DEPARTMENT OF PLANNING AND COMMUNITY DEVELOPMENT

CASE NOS.: 06-CUP-005 and 06-OTP-008 (Amendment)

LOCATION: 6160 Fairview Place
(A.P.N. 2055-023-109)

REQUEST: Request for approval of a Conditional Use Permit and Oak Tree Permit Amendment for changes to the approved grading plan and associated changes to the landscape plan.

Photo 1A – Rear Retaining Wall

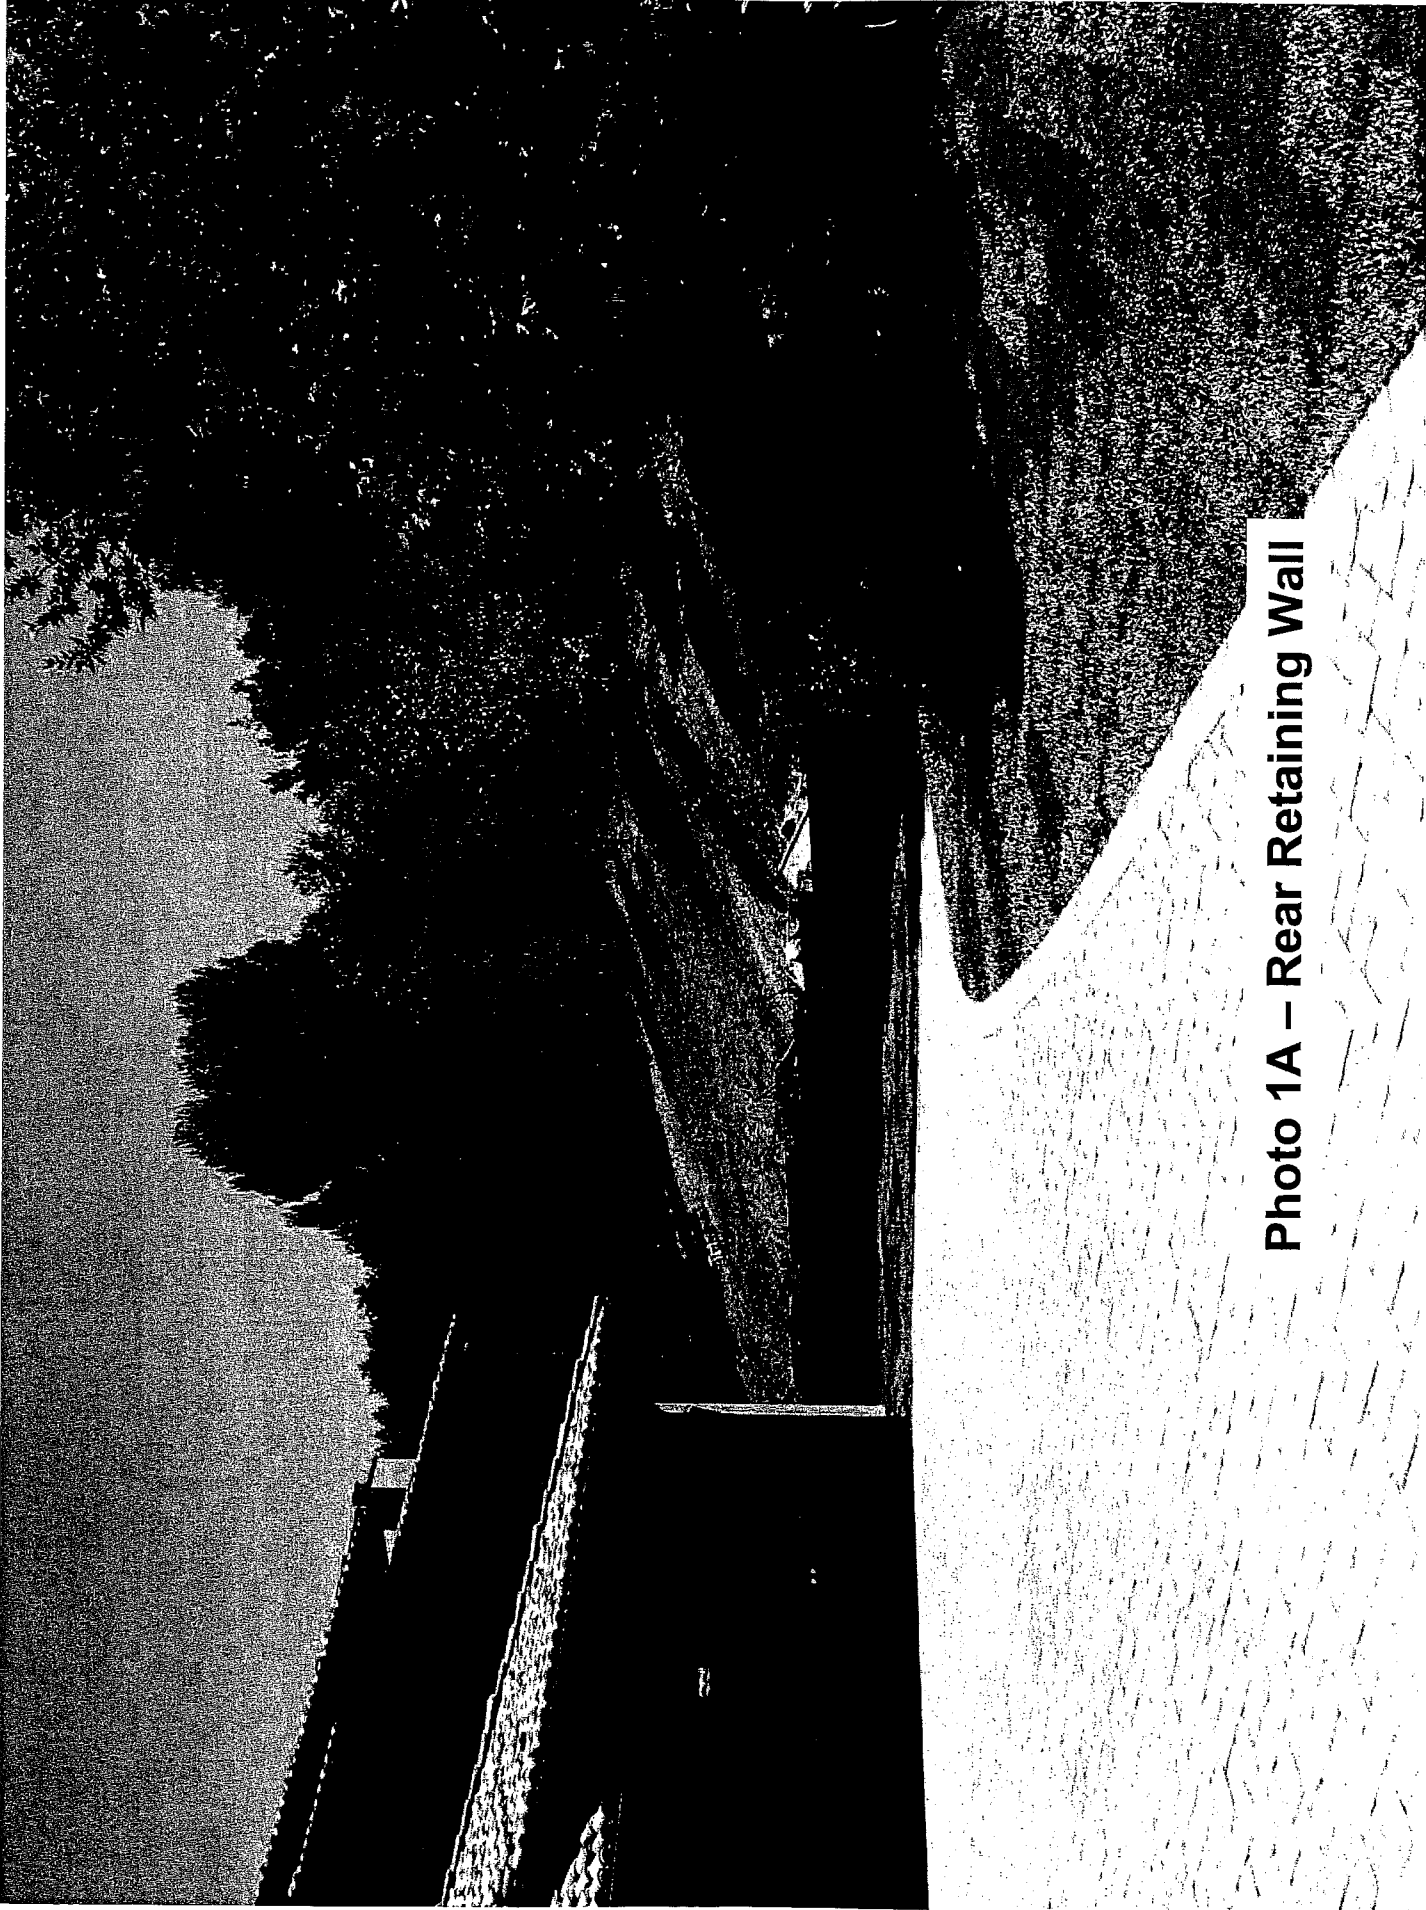
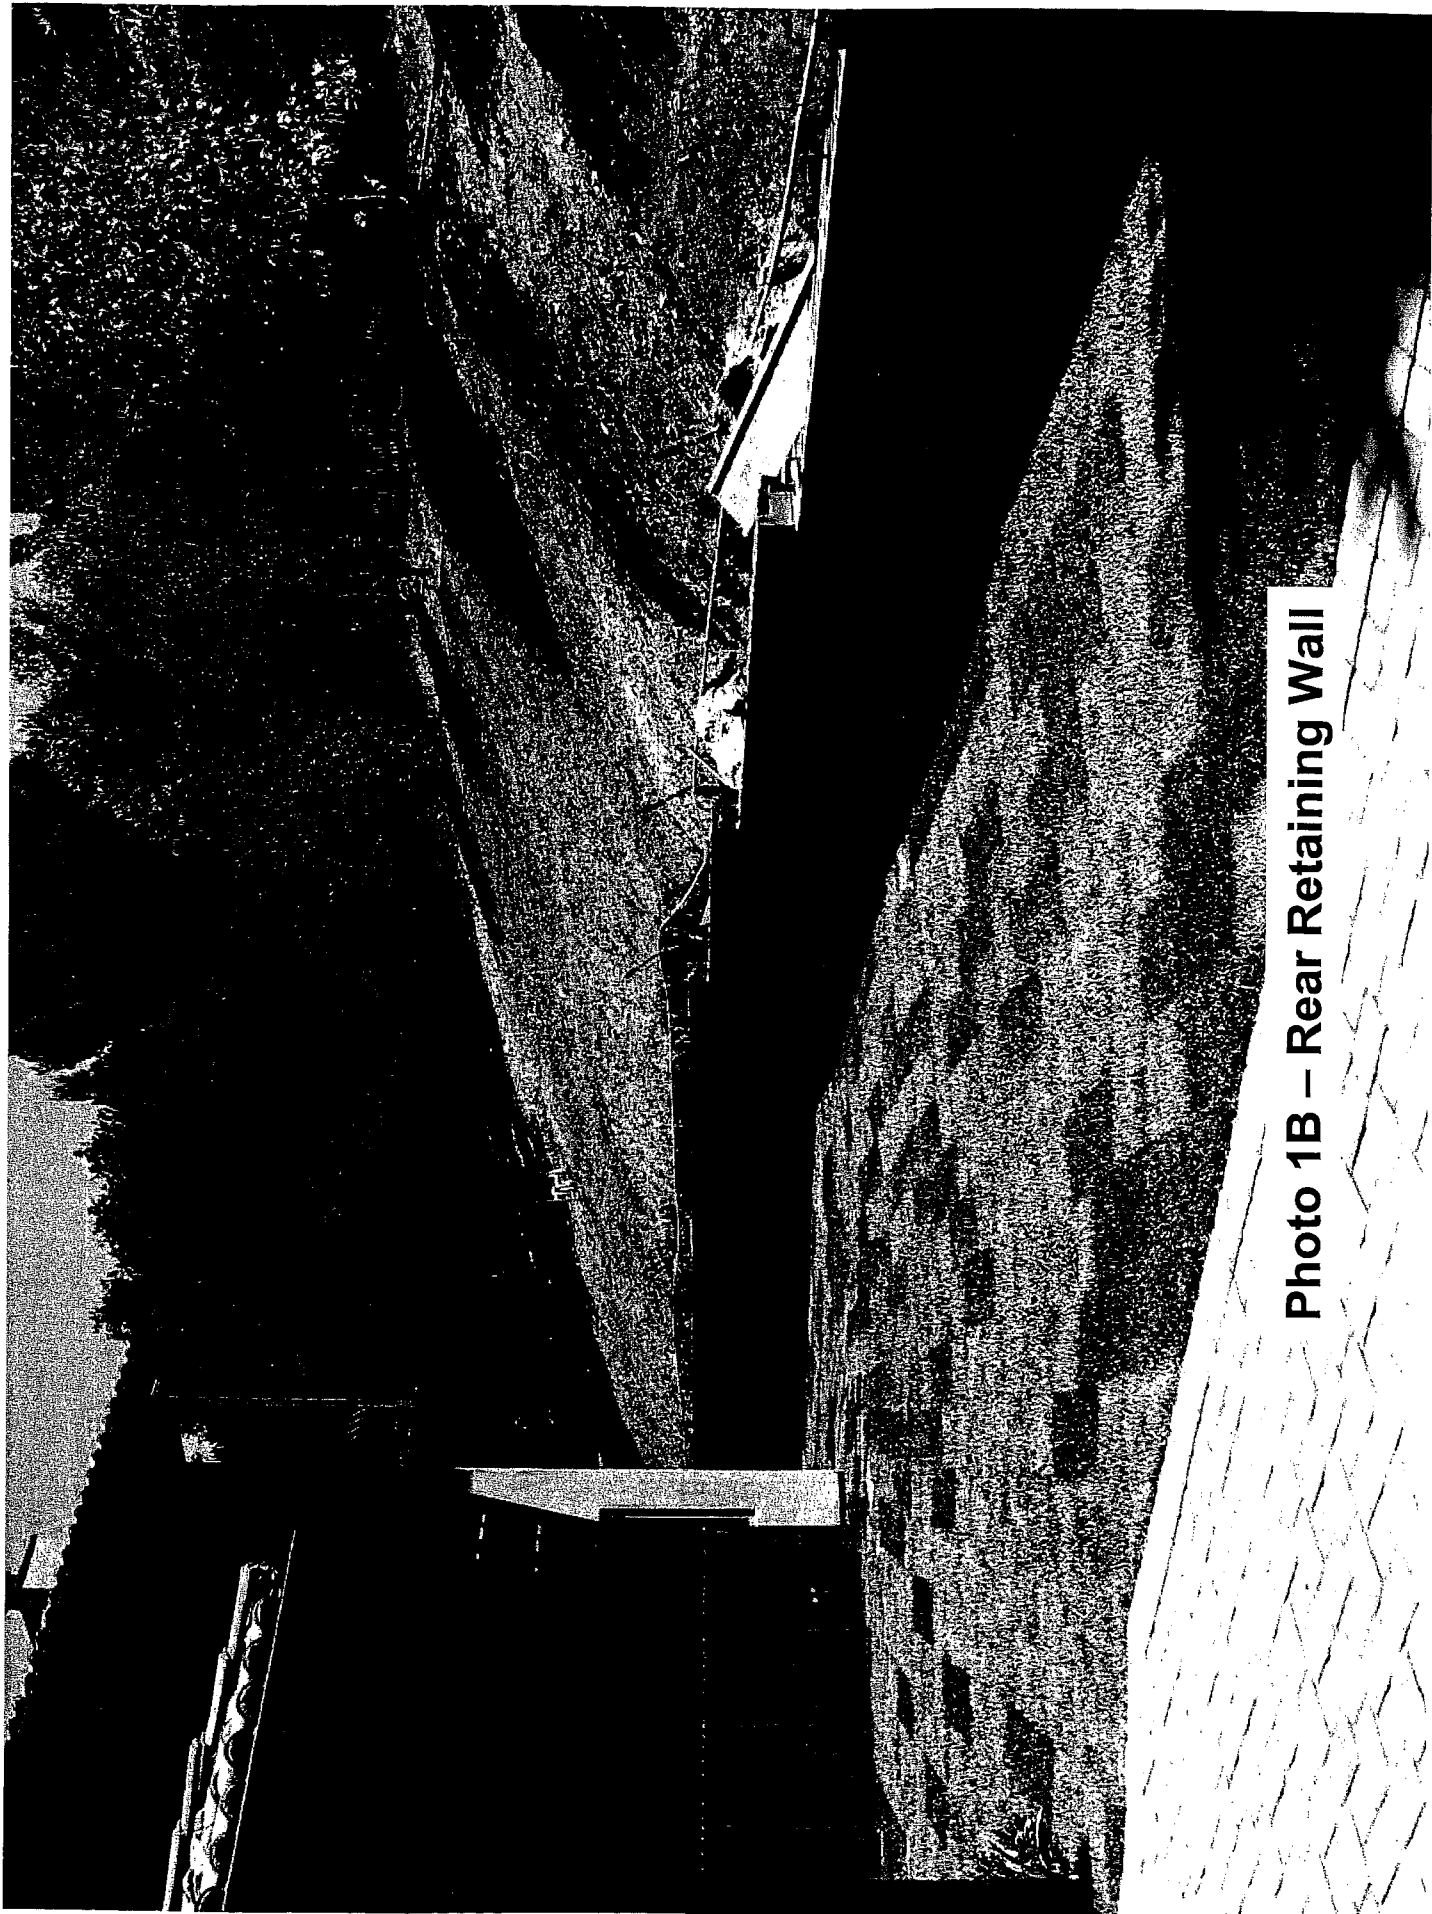
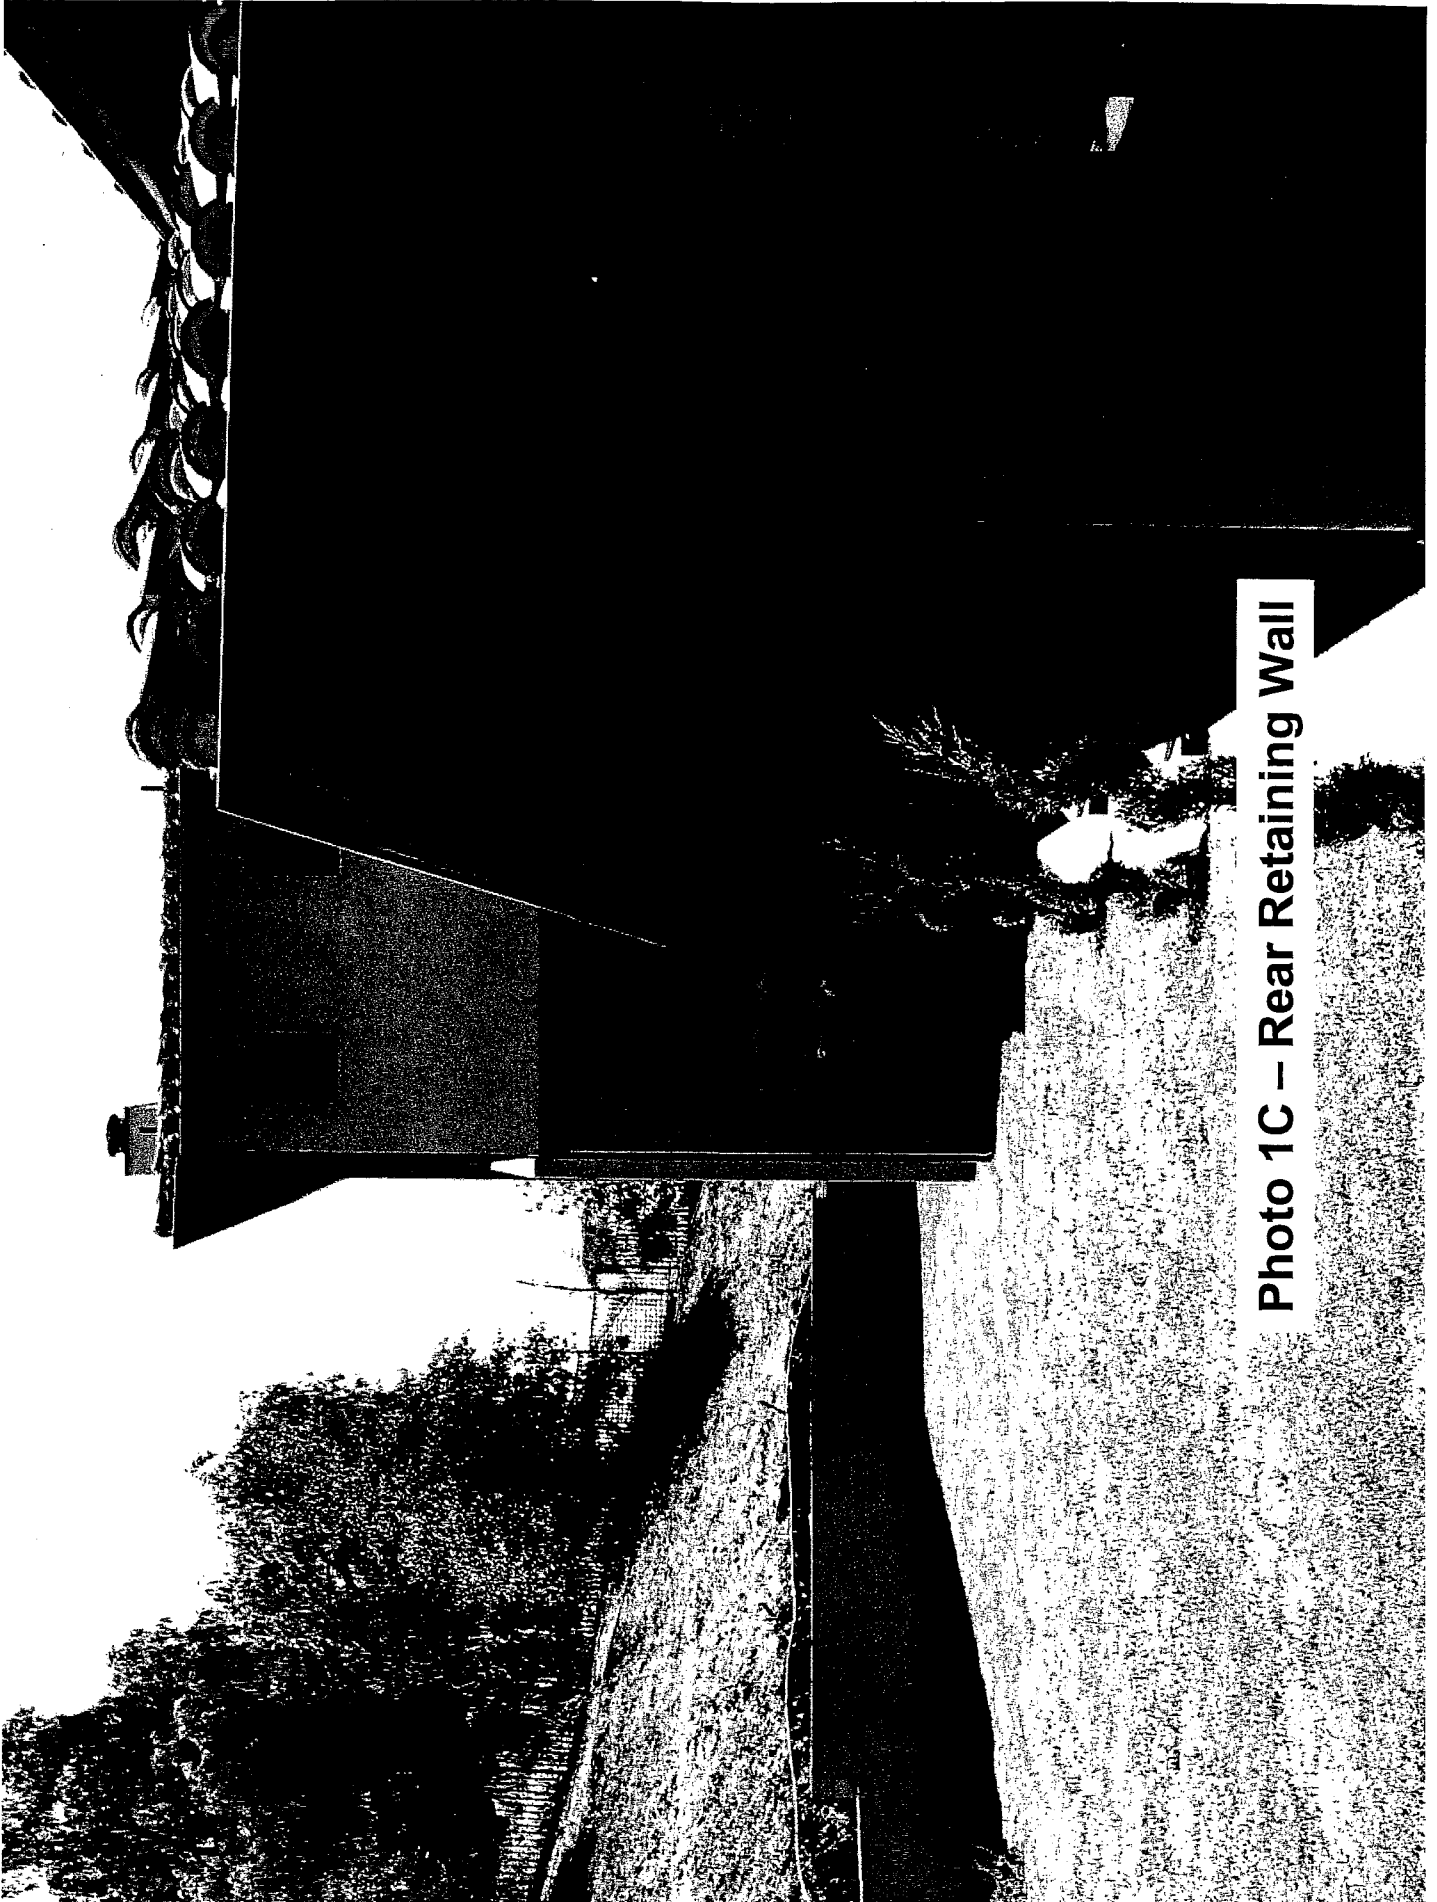
1. Rear Retaining Wall. At the rear of the house, where the property slopes upward from the building pad, he replaced a double-stacked retaining wall system with a shorter, single wall positioned further back from the house. (See Photos 1A, 1B, 1C.)
2. Stairway. At the front of the house, he moved a stairway out from the house about 6 feet and realigned it to step directly down to the curb, replacing the original design which had paralleled the curb. (See Photo 2.)
3. Front Retaining Wall. In the area around an existing oak tree at the front of the house, he moved a curving retaining wall slightly inward toward the house (ranging between a few inches and 2 feet) and extended its length by about 20 feet in order to accommodate the revised stairway design. (See Photo 3.)
4. Planter Walls. Also at the front of the house, he removed three decorative planter walls on either side of the

1. Rear Retaining Wall. The relocated rear retaining wall is no taller than the original approved design (maximum 6 feet), is substantially shorter in length, and replaces a double-stacked, or "stair-step" wall system. This is consistent with the City's Hillside Ordinance, which discourages "stair-step" grading. (See A.H.M.C. sec. 9652.5(1). The revised wall is also further from the street and thus less visible than the original design.

Photo 2: Stairway

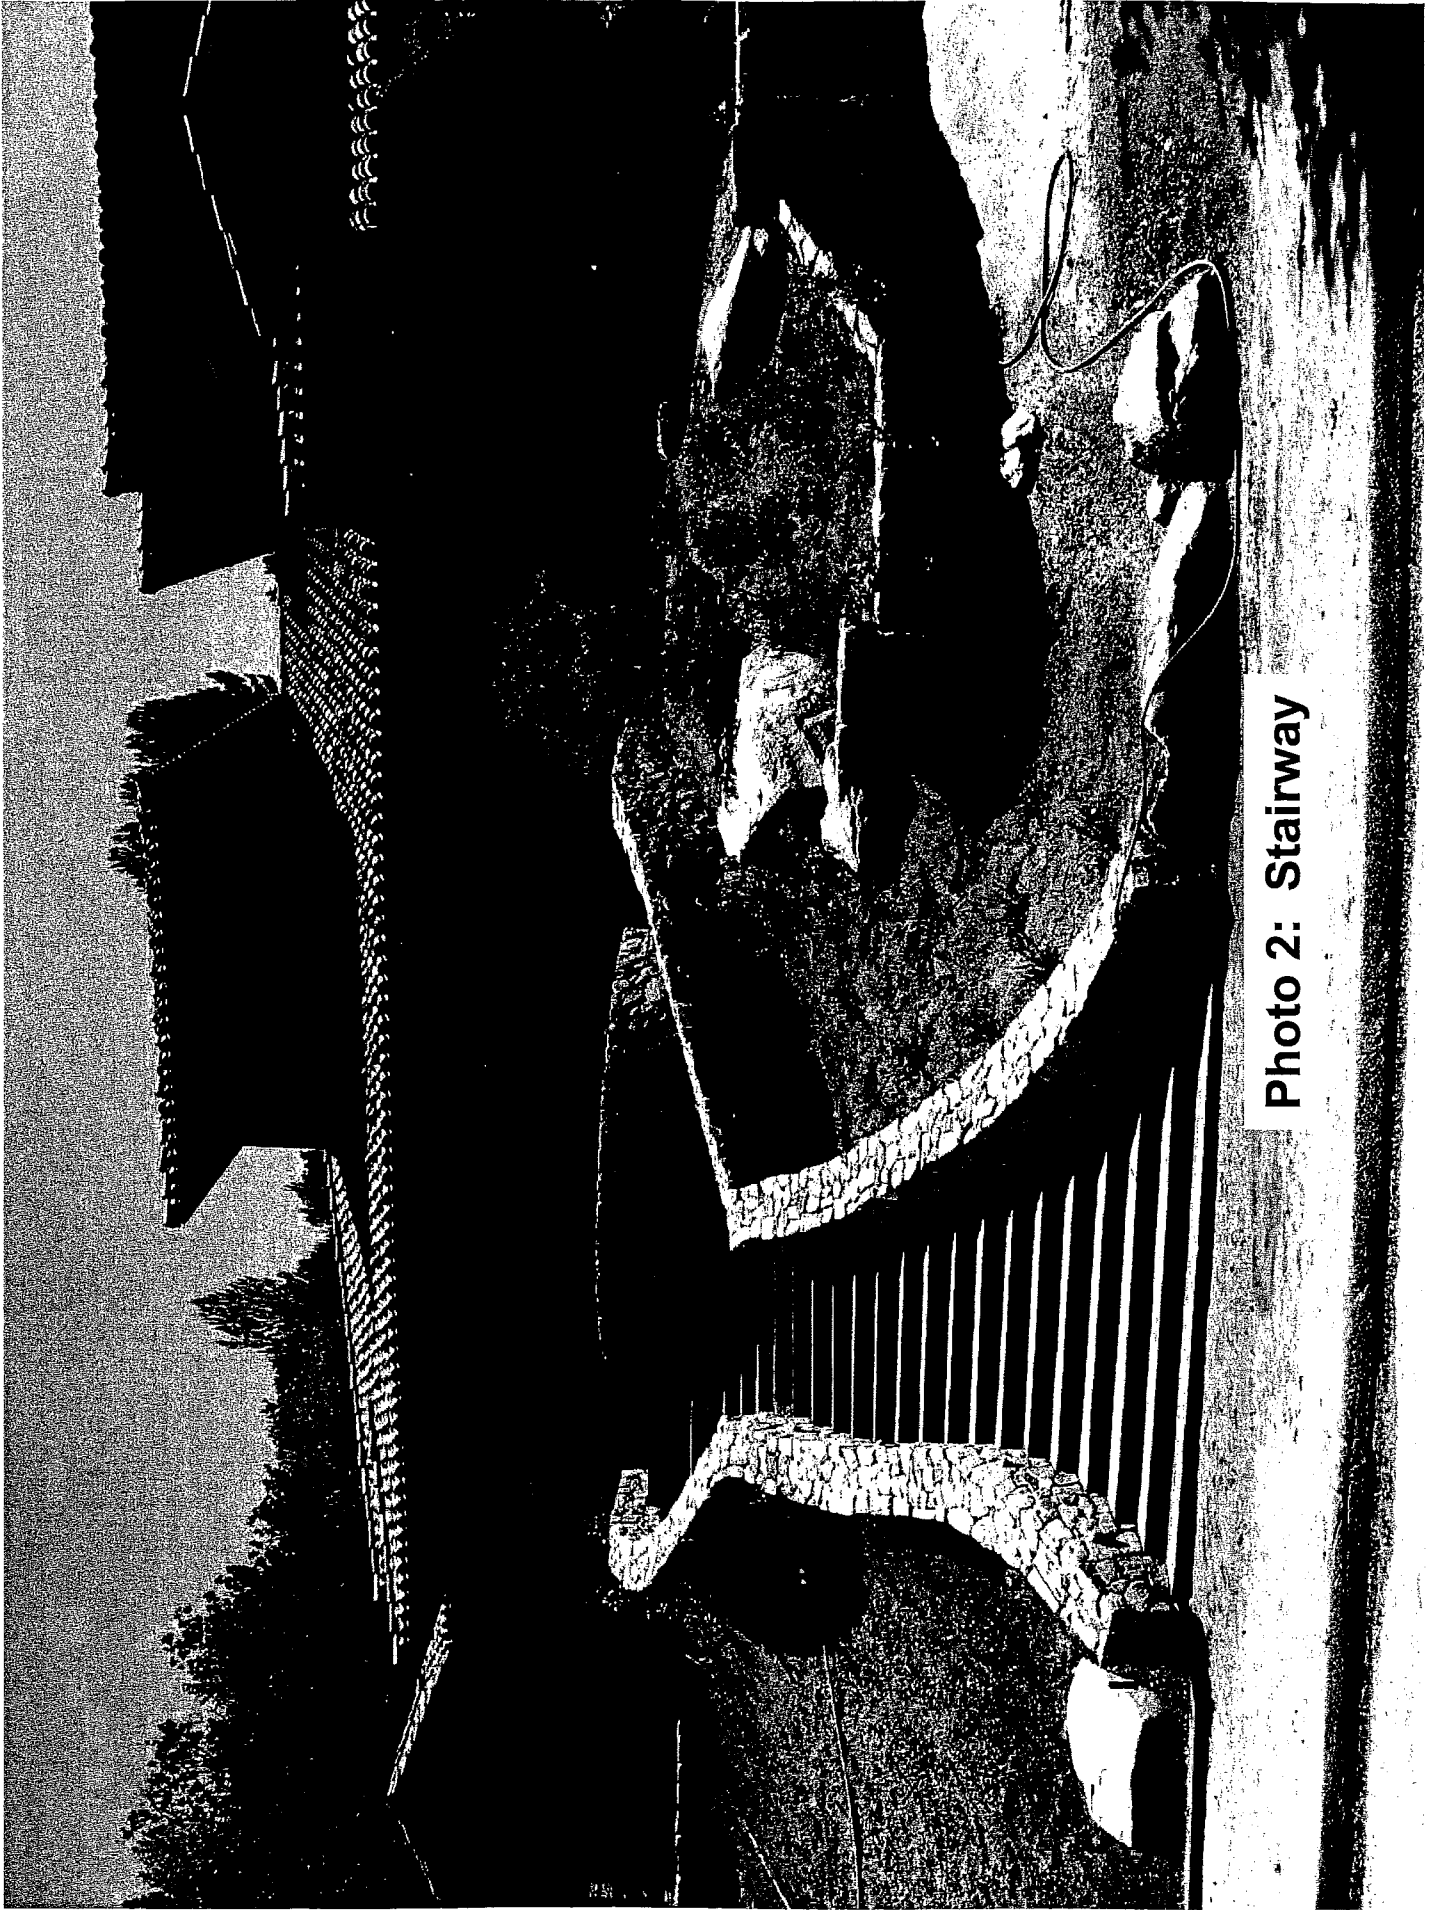
2. Stairway. The redesigned stairway is an improvement aesthetically. The stairs lead directly down to the curb, rather than parallel to it, avoiding a "wall effect" as viewed from the street.
